DOCUMENT CHANGE REQUEST

DCR number 250

Title: Connector Savers Electrical Rectangular Miniature Removable Contacts, based on type D*BMA

Number: 3401/020

Plug Contact Cavity Arrangements — High Density

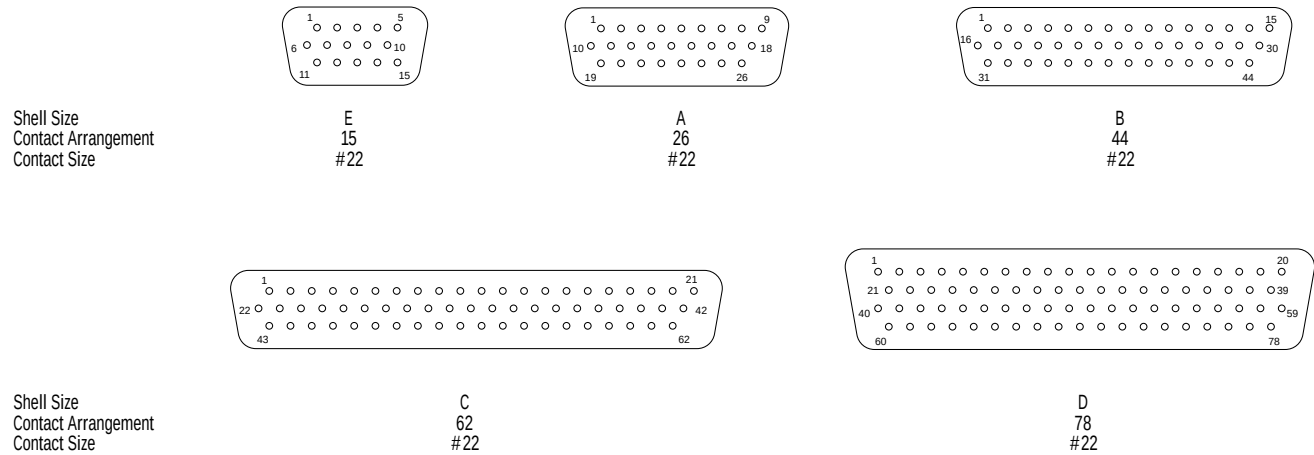
In figure 2(b) is presented the contact layout of D-connector 78 Contact, Gauge 22. The contact layout/numbering is incorrect. In picture there are presented incorrectly 79 contacts.

Correct contact layout presented in attachment.
